Revision: Issue 1
Date: 9th February 2015

Habitus Fashion Limited

Structural Inspection Report

Partial constructed expansion joint between Office building and Factory building

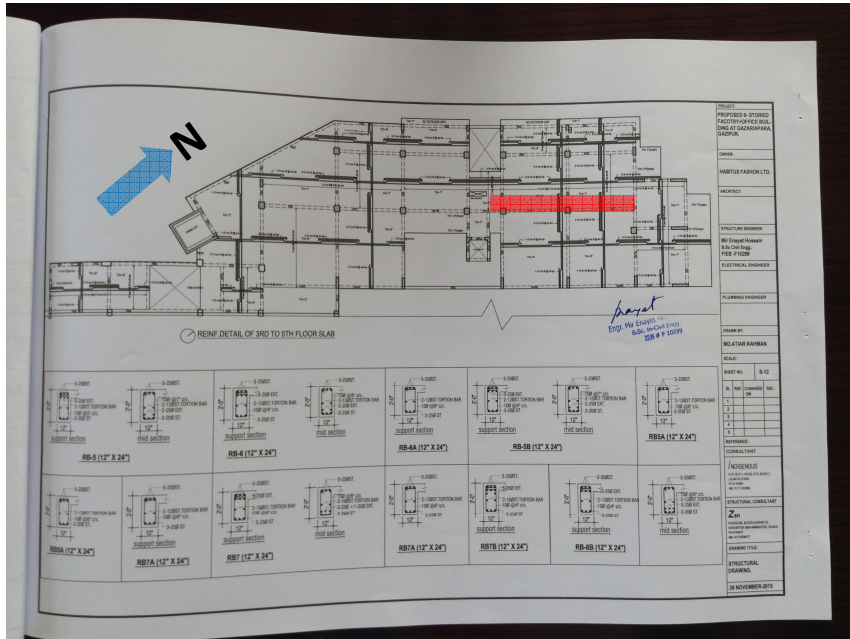
Expansion joint is constructed

No expansion joint in this area

ITEM 1: Partially constructed expansion joint between Office building and Factory building

- The Engineer is carry out a review of the partial expansion joint. Carry out any remedial works as required.

**Minor variation between structural drawing and
As-built. (beam omitted on underside of roof)**

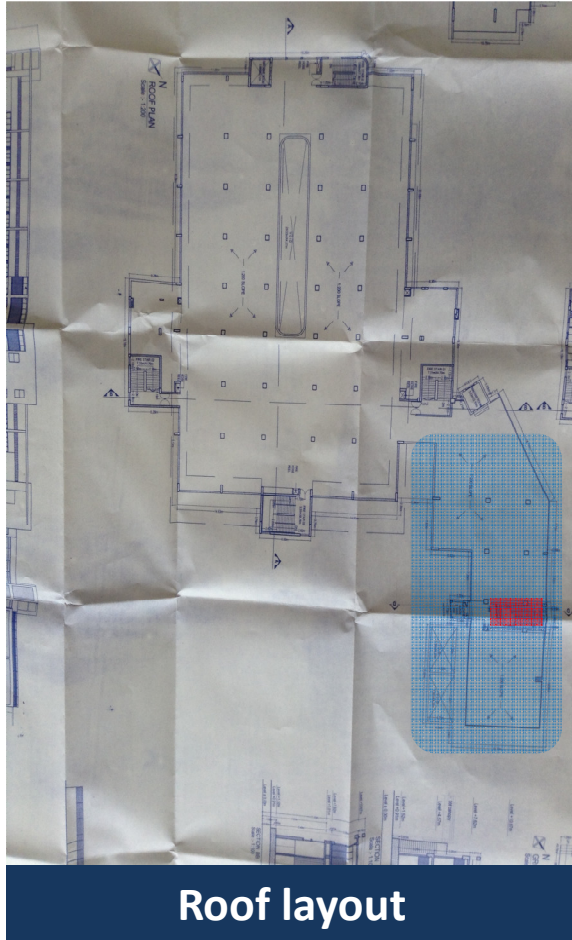
There is a beam shown on the structural drawing

No beam was found during the inspection on underside of roof slab

ITEM 2: Minor variation between structural drawing and As-built. (beam omitted on underside of roof)

- Engineer to review the difference between the as constructed roof slab and the engineering drawings.
- Carry out any remedial work if required

Water tanks on stair cores unusual construction

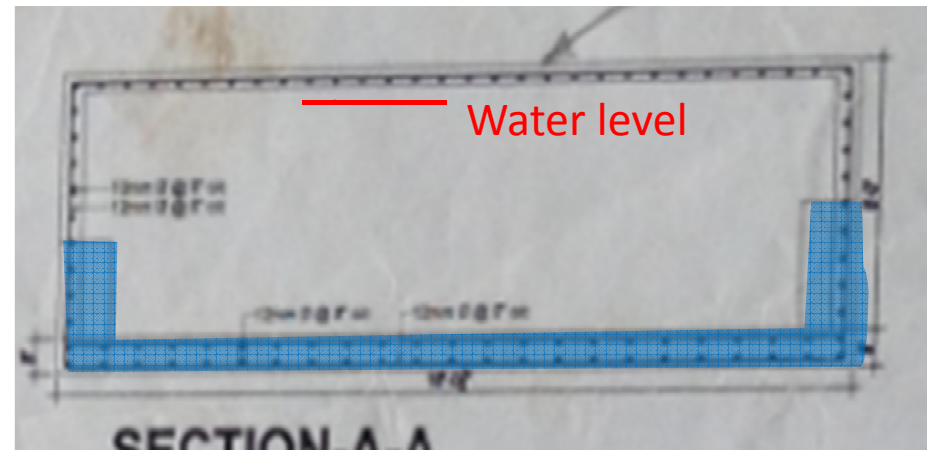
Position of water tanks

Water tank was observed on the stair cores of Office building

ITEM 1: Water tanks of unusual construction.

- The Building engineer to review the design of the water tank.
- Carry out any remedial works as required.
